Wanhao D7 Correction on 16th April 2017  
D7 V1.3 to be released on 13th April 2017

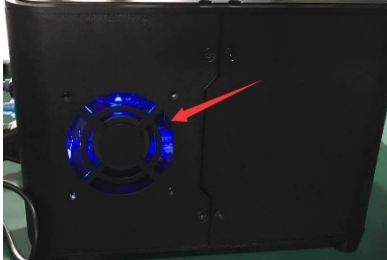
D7 Version 1.3 issue		D7 Version 1.4 improvement	
Pic	issue	Pic	Improvement
	<p style="text-align: center;"><b>1</b></p> <p>There is one intake 40*40mm fan beside the UV light. The printer is warm during printing.</p>		<p style="text-align: center;"><b>1</b></p> <p>We add the 60*60mm fan above the motherboard and on side of printer. The printer is much cooler than before.</p>
	<p style="text-align: center;"><b>2</b></p> <p>The power button at front. We have lot issue of LED light.</p>		<p style="text-align: center;"><b>2</b></p> <p>We use better switch without LED light.</p>
